Subject: RE: SUB23/0066 LUC23/0121 Melrose Road - RFI Stormwater

In terms of the roading upgrades, Glen McLaughlin and Selwyn Chang, from Davis Ogilvie, had provided the proposed cross-sections with the initial design (namely Sections A, B & C shown on plan PLO3) were for the new internal roads.

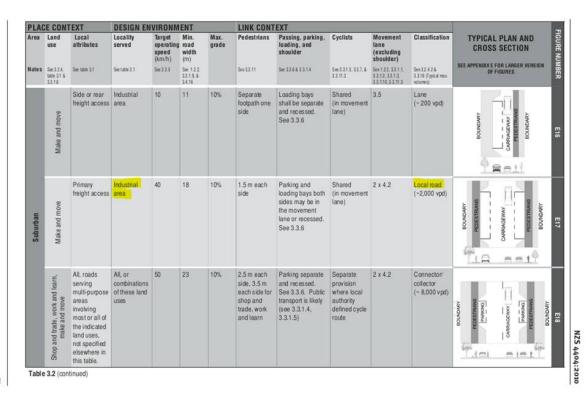
To keep it simple at this stage, Council's nominated standards, in this case Figure E17 from Table 3.2 contained within NZS4404:2010, are relevant. With the 20m road corridor that is going to be available in Melrose Road, please see below the Industrial 'Local Road' standard that would apply.

I assume the 20m is the legal width? This won't allow a swale system to treat/convey stormwater. Will stormwater be piped? How will this be treated and disposed of in accordance with our Global Consent CRC186263?

A typical cross section has been drafted showing the above
